**EPA Comment****G-2 Inventory**

*Dr. Leigh noted during her April 20, 2004, presentation – “TRU Waste Inventory CRA-2004” – that plastic wrap, slip sheets, and other emplacement materials external to the waste containers are not accounted for in the performance assessment inventory data values for cellulose, plastic, and rubber (CPR) in the disposal system.*

**Figure 1. CRA PA and CCA PAVT Spallings Release Means, All Replicates Pooled**

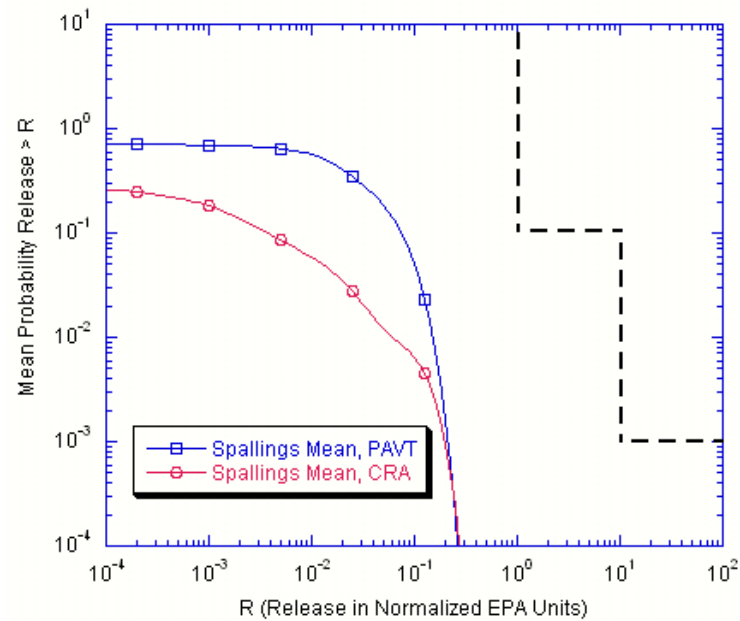
*The previous baseline for DOE's compliance (from the initial certification decision completed in 1998) is the Performance Assessment Verification Test (PAVT) set of CCDFs and releases at the regulatory limits. To provide context for understanding the changes from the previous baseline, DOE must provide a comparison of the CCA PAVT results to the results of the CRA PA in a tabular form with columns/rows for 0.1 and 0.001 probabilities. For the table, use as an example the table submitted as part of the review of super compacted waste (Comparison of AMW and PAVT Results with CRA Results by C.W. Hansen, March 19, 2004. ERMS 534241 and EPA Docket A-98-49, Item II-B2-34).*

The CRA PA releases at probabilities of 0.1 are smaller than the CCA PAVT releases at the same probabilities due to a decreased contribution of spill. The typical spill release in the CRA PA at a probability of 0.1 is smaller than the typical spill release in the PAVT CCA at the same probability (Figure 1).

Figure 1: Disturbed Rock Zone around a Raised Disposal Room in the Absence of Gas Generation (Park and Holland, 2003).  
(MB 138 is represented by the upper (thinner) anhydrite layer, and MB 139 is the thicker (lower) anhydrite layer)

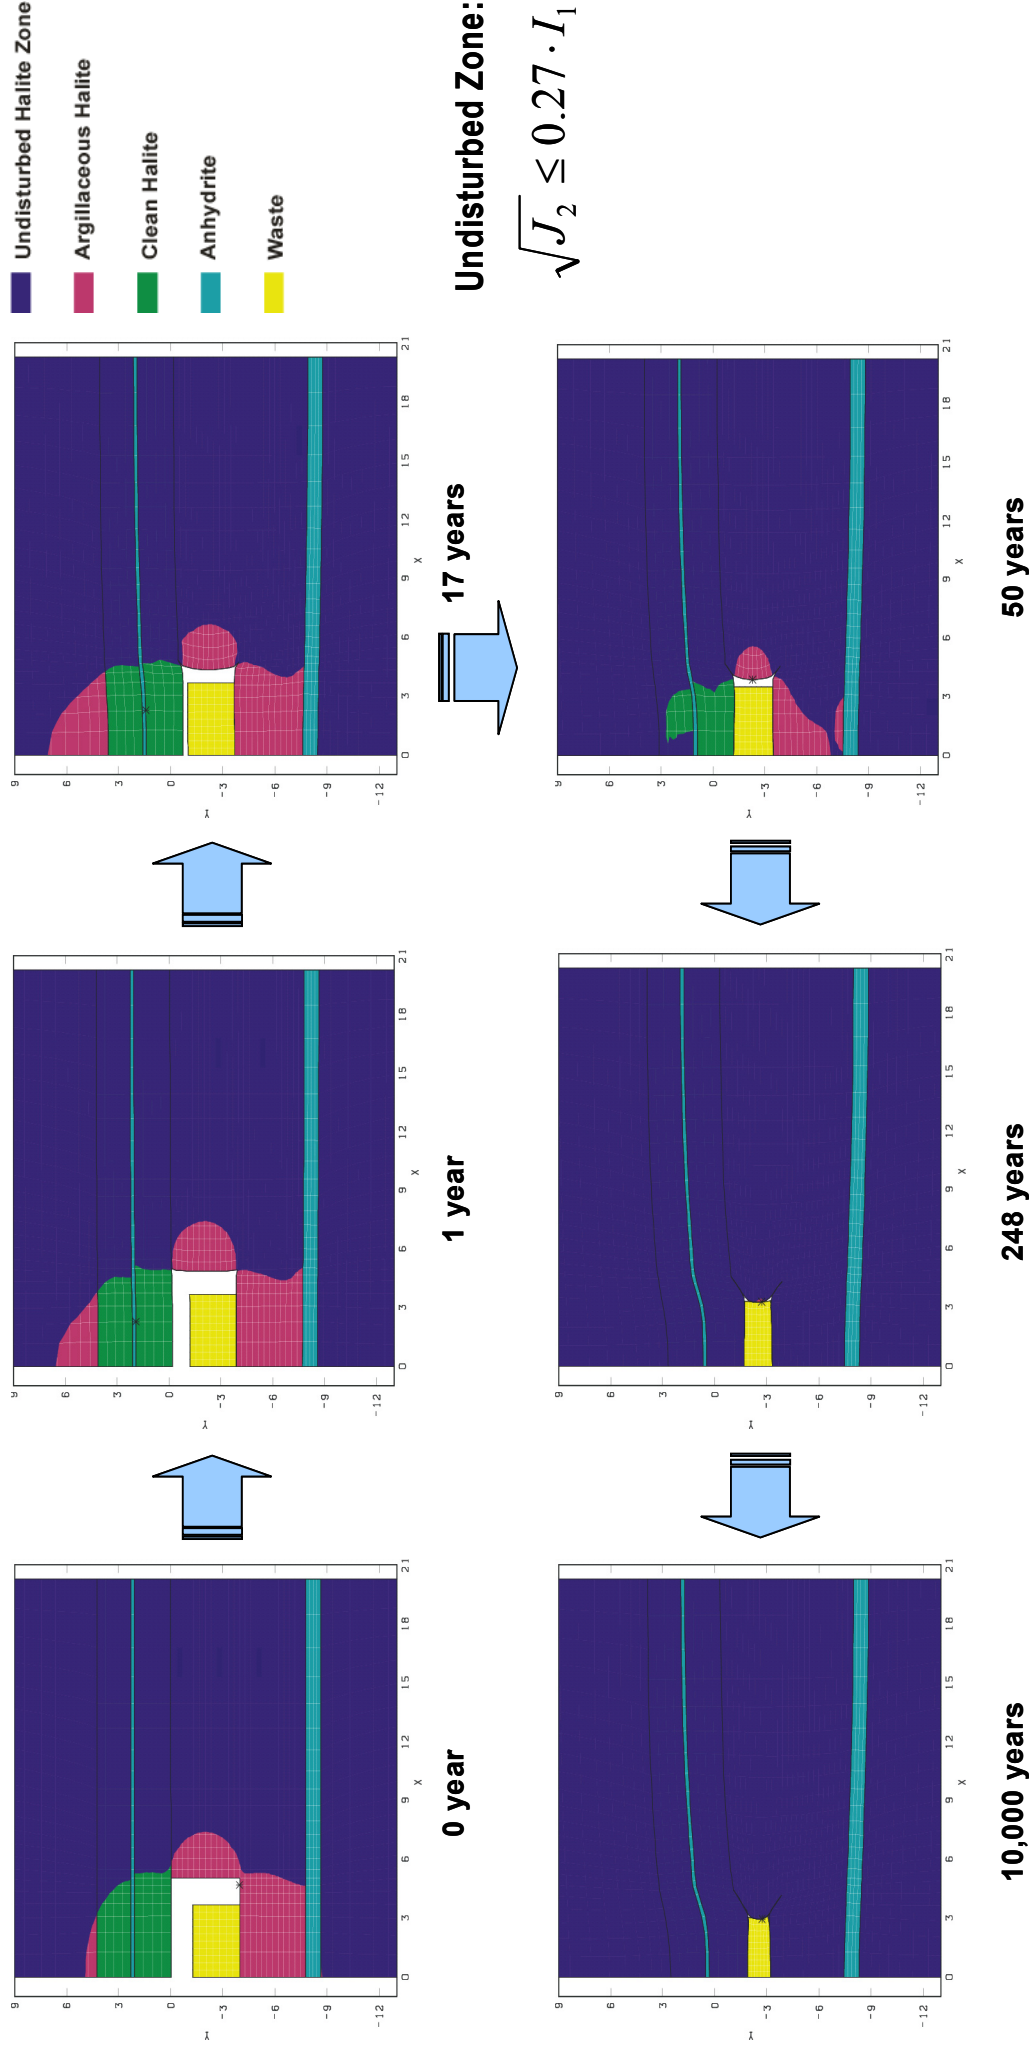
*The CRA states that the "DRZ would not reach MB 138." DOE must supply documentation to justify this assertion.*

Details of the Clay G analyses also provided insight to the local behavior of the DRZ evolution and devolution and the distortion of the anhydrite layers near the disposal rooms. An example of DRZ calculations is shown in Figure 1. These calculations at the raised horizon invoke principles of damage and healing as discussed by Hansen (2003). For the raised repository, the DRZ does not penetrate Marker Bed 139. The DRZ did penetrate Marker Bed 139 for the original horizon condition. The DRZ extends to its greatest dimensions in the period before the surrounding salt makes contact with the waste. Based on the modeling results, the maximal extent of the DRZ above the rooms is 6.5 m. The distance to MB 138 is 12 m and 9.5 m for the normal repository horizon and the elevated horizon, respectively.

Between 10 and 20 years, the creeping salt will begin pushing against the waste stack, a condition that decreases the driving stress difference. Shortly thereafter the stresses in the salt transcend from damaging to healing conditions. There is no time dependency applied to the healing process, because empirical evidence shows that healing would be rapid and the DRZ would diminish as depicted in Figure 1.

Thus, the geophysical testing and modeling results show that the DRZ is limited in extent and heals as the salt compresses the waste. Therefore, the DRZ would not reach MB 138.
